UNITED STATES PATENT AND TRADEMARK OFFICE

| APPLICATION NO. | FILING DATE | FIRST NAMED INVENTOR | ATTORNEY DOCKET NO. | CONFIRMATION NO. |
|-----------------------------------|-------------|----------------------|---------------------|------------------|
| 10/680,716 | 10/06/2003 | Tuoc Tan Nguyen | 816020-100045-US | 2647 |

Office Action Summary

DETAILED ACTION

Attachment # 1 (marked up)

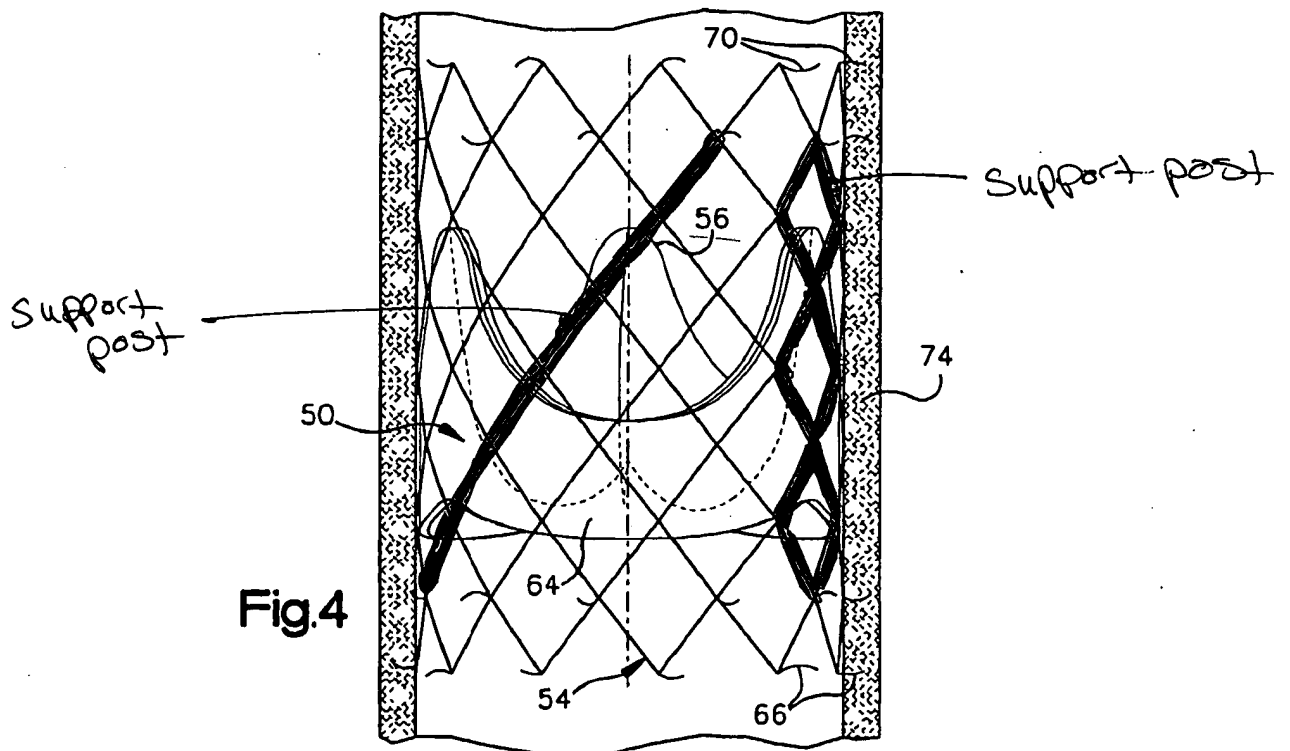
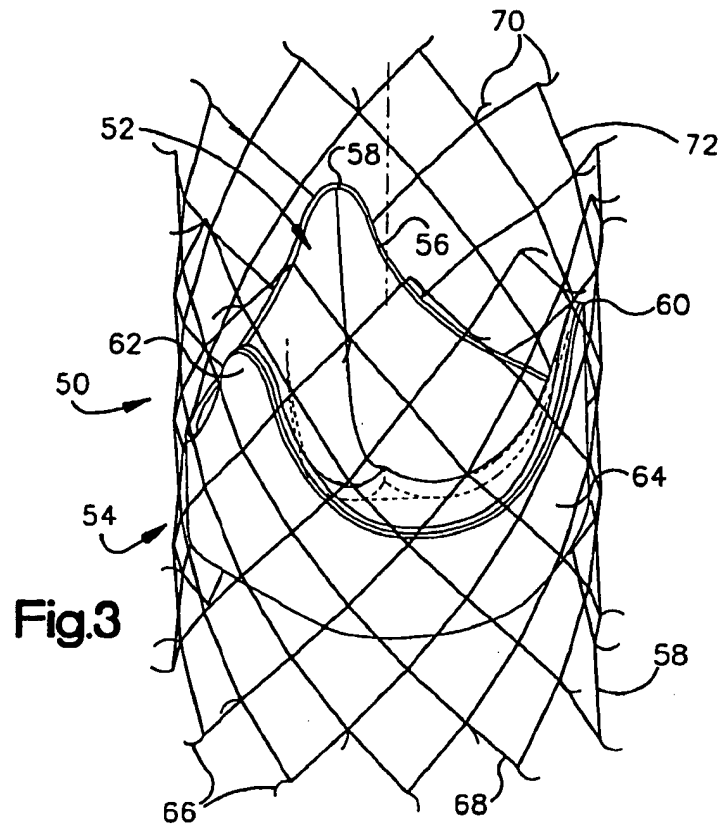
Claims 1-2 and 5-17 are rejected under 35 U.S.C. 102(e) as being anticipated by Gabbay (US 2003/0040792 A1). Gabbay discloses an assembly (fig.2, 4, 14, 18) comprising a replacement valve (12, 472, 590) having leaflets (22, 24, 26; 480) and a scalloped inflow annulus (inflow annulus is shown to be scalloped in all figures, but most clearly seen in figs. 1, 4, 15, 24) and an expandable anchoring structure (14, 420) having flared rims (see fig.15, 18, 14, 11, 2) and a plurality of support posts (any element seen in red in attachment 1) extending between the rims. Gabbay discloses the valve (12, 472, 590) to be positioned internal of the anchor structure (see figs). Gabbay discloses support posts to comprise a triangular window (attachment 1) *capable* of accommodating tabs. Gabbay discloses the support post to extend beyond the outflow rim (in the form of barbs 66, 70; see fig.3). Gabbay discloses the inflow rim of the anchor structure to have one or more rings in undulating patterns and the outflow rim to comprise one or more rings in an undulating pattern connected by a vertical element (see attachment 2).
